## SERVICE BULLETIN

REVISION AND MODIFICATION OF THE AUTO SHOCK NOSE TYPE GEAR, CORRESPONDING TO THE DRAG DISTANCE (Trail "T<sub>M</sub>")

**SB-Ibis-007**

(Figure 1).

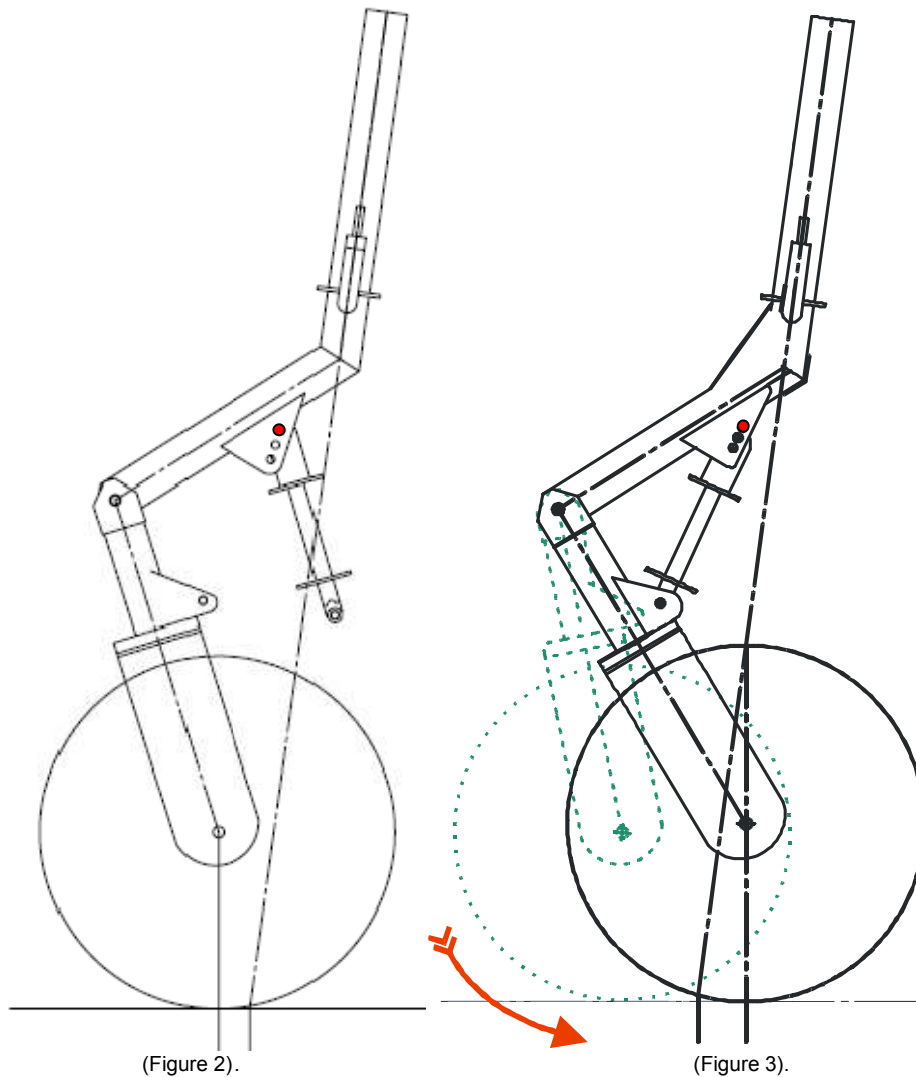
- The aircraft should be kept in a straight and level taxiing position, also in a straight and level ground.
- Thereafter, proceed to perform the inspection on the nose gear and it must meet the following specifications (Figure 1):

Here should be noted that the angle (TETA  $\theta$ ) for the angle of the wheel (Caster Angle) must be in the range of 0 to 15 degrees and the tow distance (Trail "T<sub>M</sub>"), should be in the range of 30 to 40 mm.

If the results obtained during the inspection show that the parameters are within the range of the design, do not run any kind of modification on the nose gear.

If the results fall outside the parameters you must run a check up of the gear again changing the positions of the upper bearing of the shock. If any of the positions in the gear is within range, you will not need to run any other changes.

If the inspection results are still outside the design parameters it's necessary to do the change in the auto-shock nose-type gear that it's indicated below.

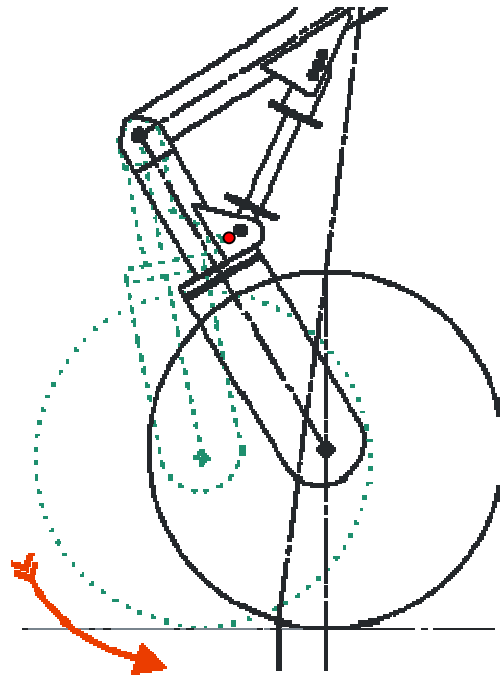
- ✓ Initially, secure the top base of the shock absorber at the highest point of the gear's plate, and then set it (Figure 2).

Now remove the fixation at the bottom of the shock absorber in order to locate the wheel within the established range of the gear's design. This is done by moving the whole wheel setting toward the inside of the aircraft (Figure 3).

(Figure 4).

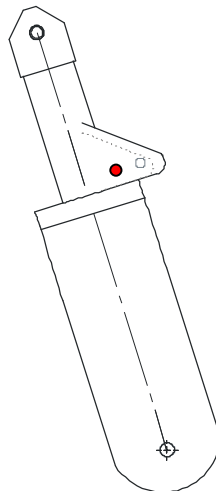
Once the position of the train is within the range is going to mark a new starting point to drill the new position of the base of the shock absorber to the nose gear (Figure 4).
